PRELIMINARY

SP245

v1_Preliminary Plan Drawings.pdf Markup Summary

7 of B SHEETS

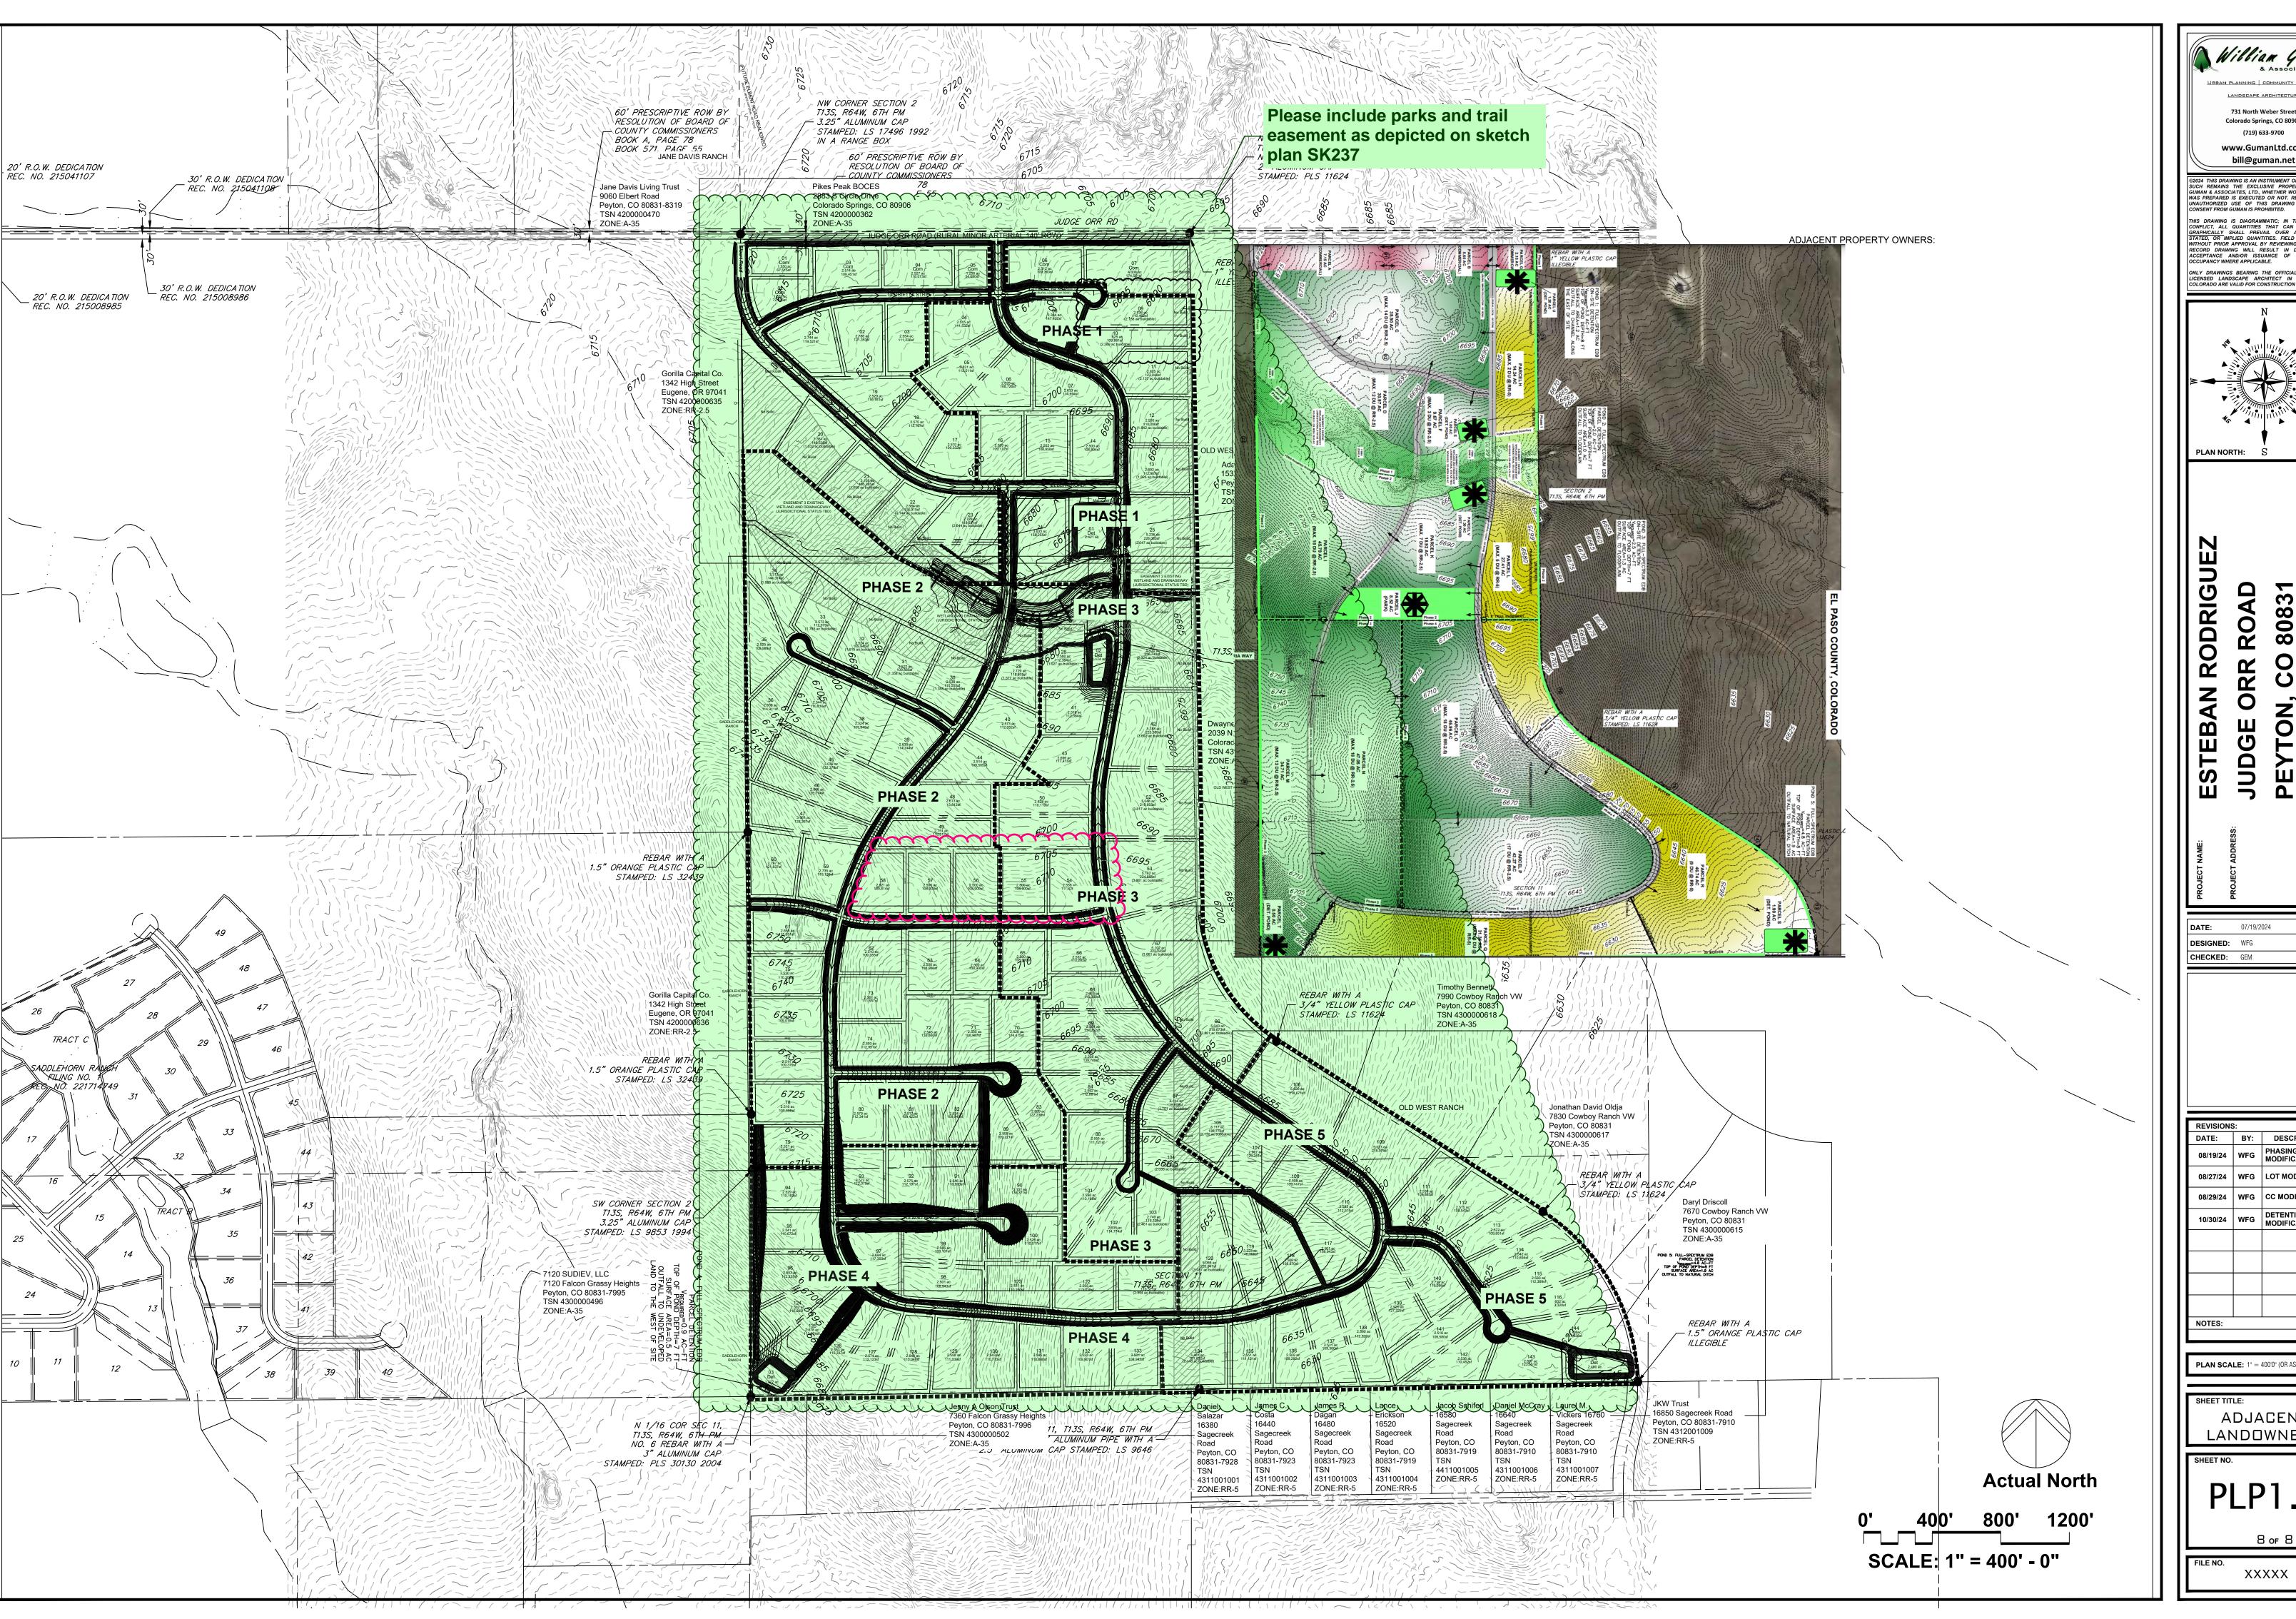
Status: Color: Layer: Space: show the pond or revise pond labeling. This pond

Status: Color: ■ Layer: Space: Please make the phase border linetype thicker and/or a different color. Anything to make it more clear. As is, the border is hard to follow amongst the contours. Shading each phase a different color

could help too. Thanks!

Status: Color: ■ Layer: Space: Which phase is this area?
